Record of Executive Business and Chief Executive's Order

Reg. Reference: SD22A/0373 **Application Date:** 29-Sep-2022
Submission Type: Additional **Registration Date:** 04-May-2023
Information

Location: Former steelworks factory, Manor Avenue, Terenure, Dublin 6W

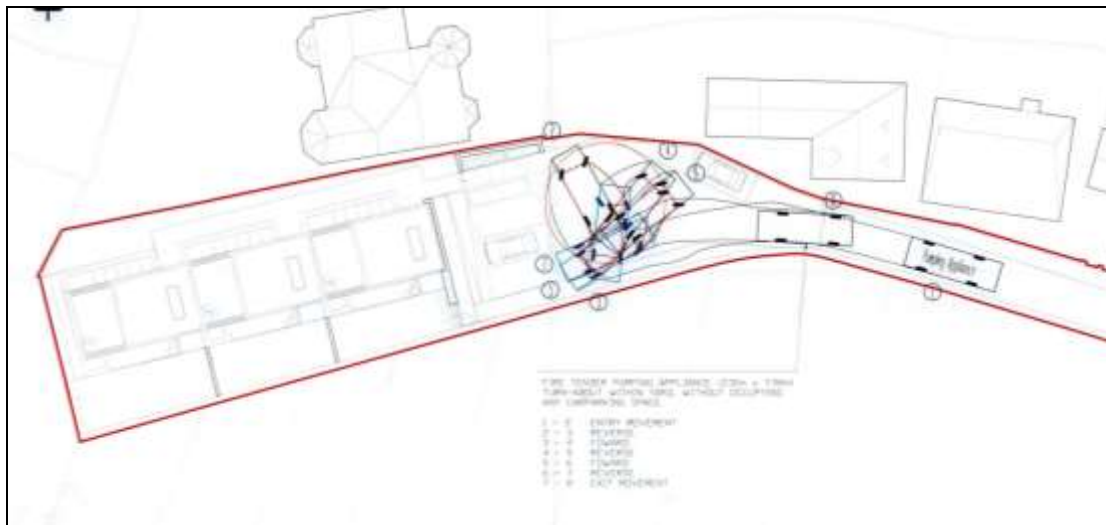
Due to the access laneway being narrow and lacking any pedestrian or public lighting facilities, it would be reasonable to assume that the vast majority of journeys to and from the site will be made by car. SDCC Roads Dept. therefore considers the parking provision to be low. This under provision could lead to the haphazard parking of residents and visitors vehicles resulting in a traffic hazard.
